The Commission has issued the enclosed Amendment No. #4 to Facility Operating License No. DPR-44 for Peach Bottom Atomic Power Station, Unit No. 2. The amendment includes Change No. #5 to the Technical Specifications, Appendix A, and is an interim measure to allow operating flexibility while the proposed change as requested in your application of July 12, 1974, is under consideration.

PEACH BOTTOM ATOMIC POWER STATION, UNIT NO. 2

AMENDMENT TO FACILITY OPERATING LICENSE

Amendment No. # 4
License No. DPR-44

FIGURE 3.5.1

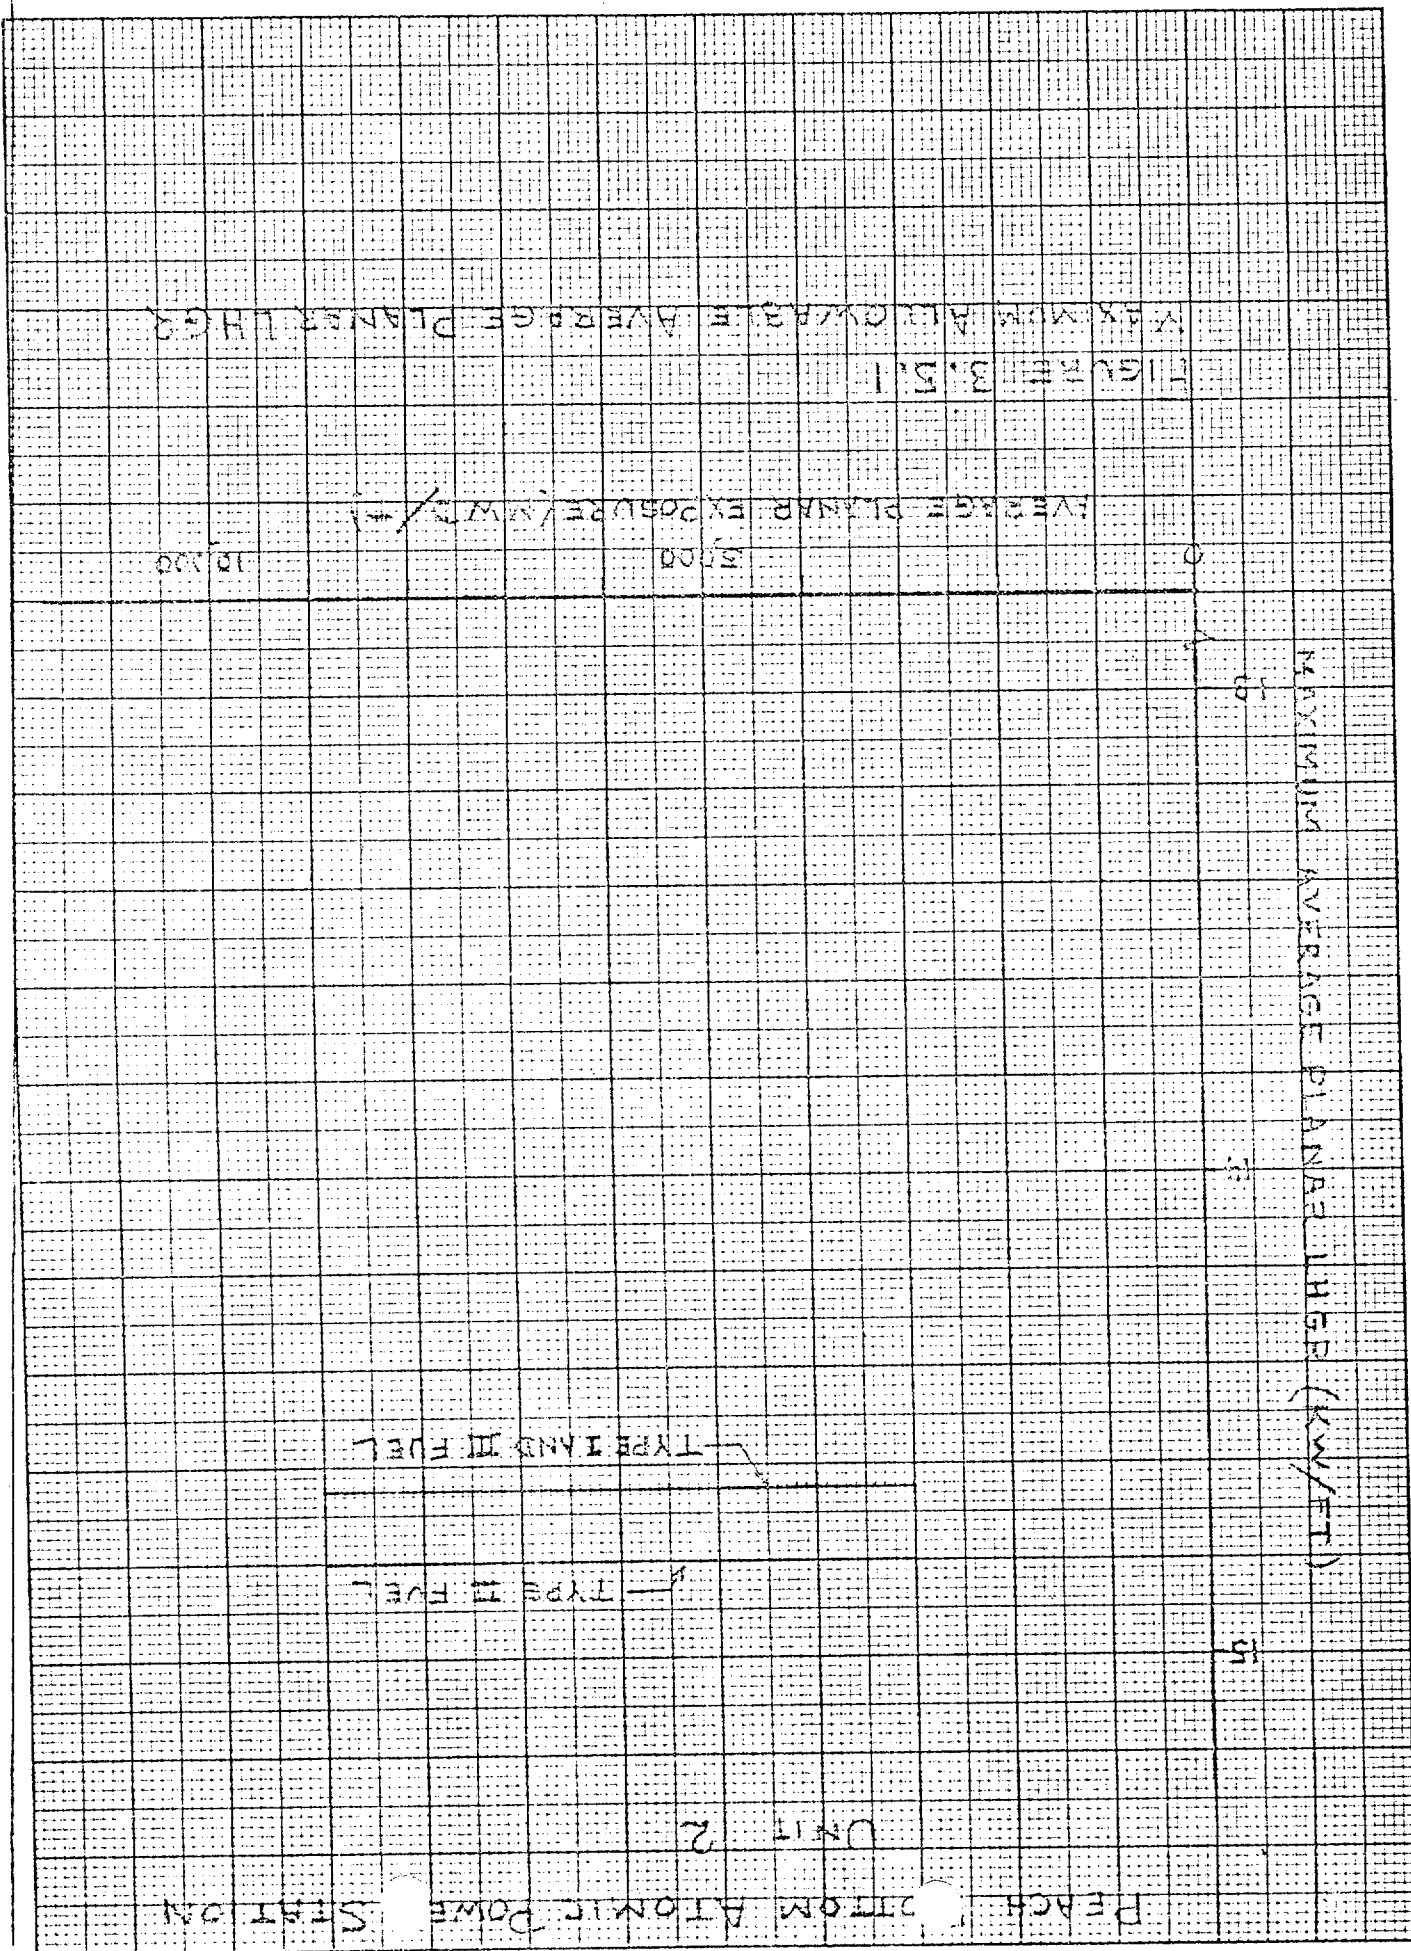
The amendment permits operation with revised maximum average planar linear heat generation rate curves up to an average planar exposure of 9000 MWD/T.

During steady state power operation, up to an average planar exposure of 10000 MWD/T, the average linear heat generation rate (LHGR) of all the rods in any fuel assembly, as a function of average planar exposure, at any axial location, shall not exceed the maximum average planar LHGR shown in Figure 3.5.1.A.*

In order to allow operating flexibility during the period when the Commission is considering PECo's July 12, 1974 submittal, the staff has reanalyzed the MAPLHGR curve in the present Technical Specifications of Unit 2 and has determined a revised curve which applies up to an average planar exposure (fuel burnup) of 9000 MWD/T. based upon the more accurate data concerning gap closure due to pellet cracking and time dependent fuel densification which has become available since the Technical Specifications for Peach Bottom Atomic Power Station, Units 2 and 3 were issued. This improved data base is a limited part of the changes involved in the request to modify the MAPLHGR curves based on GEGAP III.

The staff has recalculated the fuel temperature response to the design basis loss-of-coolant accident for Peach Bottom Atomic Power Station, Unit 2 and has determined new MAPLHGR curves for the three fuel types presently in use.

The 2300°F peak clad temperature of these curves (Figure 3.5.1.A of the revised Technical Specifications) maintain the Interim Acceptance Criteria (IAC) during a loss-of-coolant accident (LOCA) while allowing steady state power operation at higher average planar linear heat generation rates.

The staff's current calculation modifies the previously performed calculation by incorporating pellet densification based on actual fuel burnup and a reasonable gap closure due to pellet cracking and relocation. Of the two effects gap closure is the dominant effect. For constant operating conditions, the consideration of fuel pellet-clad gap closure increases the calculated thermal conductance for the gap, reduces the calculated fuel pellet stored energy and reduces the calculated peak clad temperature following a LOCA. Conversely for a constant calculated post-LOCA peak clad temperature the MAPLHGR can be increased when gap closure due to pellet cracking and relocation is considered.

The recalculated MAPLHGR values using previously used calculational methods, maintain calculated peak clad temperatures within the limitations of the IAC and consequently provide assurance of adequate ECCS performance in the event of a LOCA. The changes do not increase the probability or consequences of any accidents previously considered or do not significantly affect safety margins.
